1990 - 1992 Corvette ZR-1: Service Bulletin: No Start Condition (Replace Starter)

Subject: NO START CONDITION (STARTER CORROSION-REPLACE STARTER)

Model and Year: 1990-1992 Corvette, Engine Code J (LT5)

Bulletin Number: 92-307-6 - (09/21/1992)

Figure 1

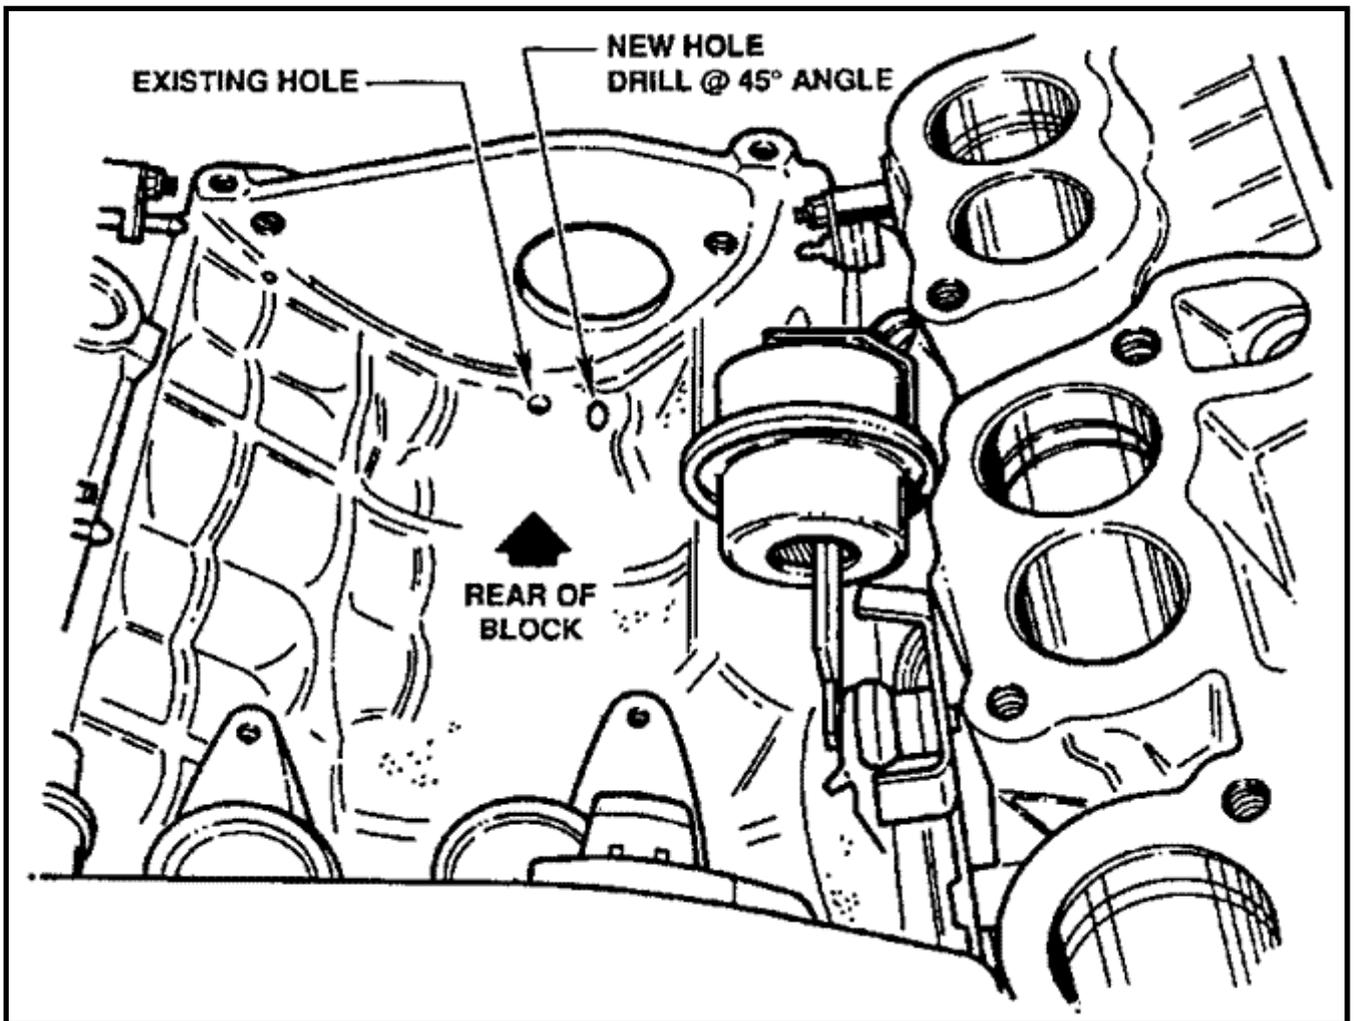
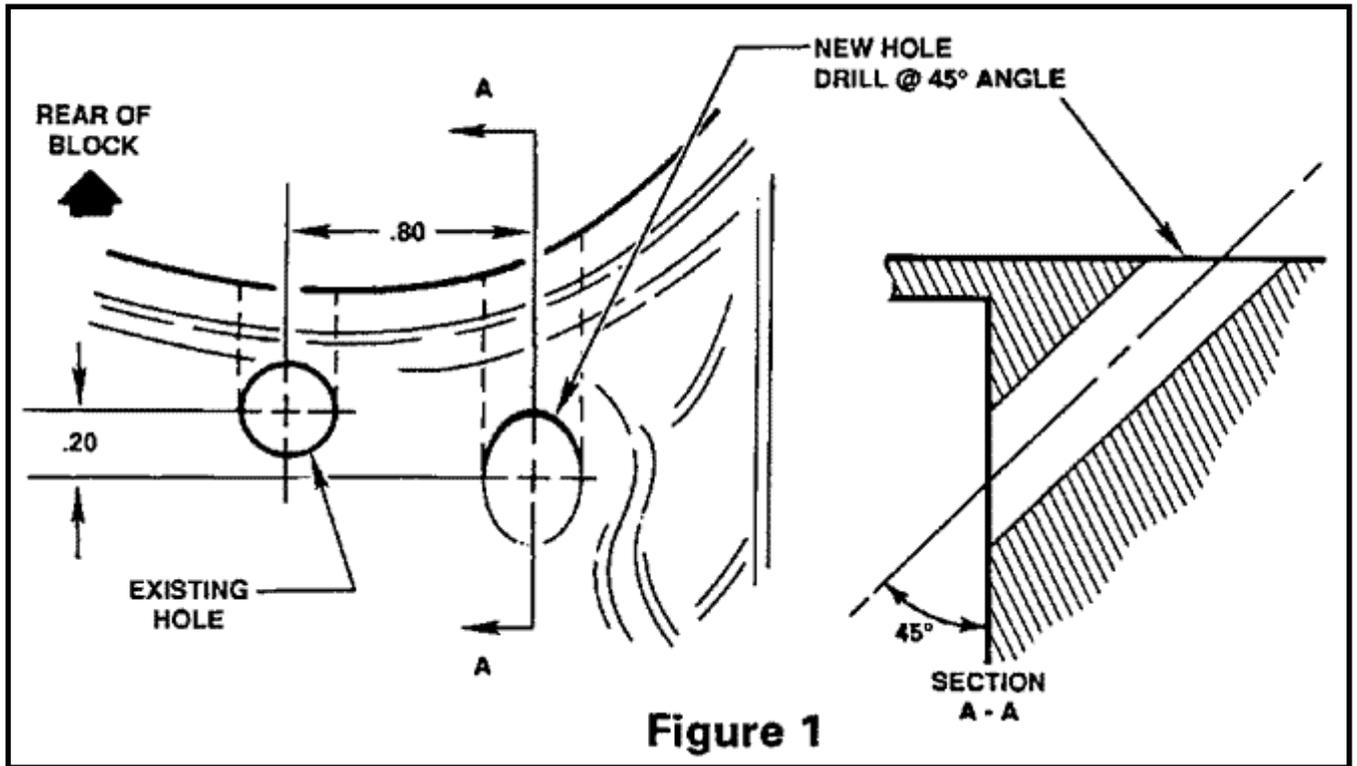
The starter on an LT5 engine is mounted in the engine "vee." A drain hole and drain tube are located at the rear of the engine valley. While washing the engine, debris may settle in the engine "vee" and block the drain system.

- 1 . Remove the old starter.
2. Clean any blockage in existing drain system.
3. Drill a 3/8" diameter hole through the engine "vee" to the back of the engine, allowing drainage (see Figure 1).
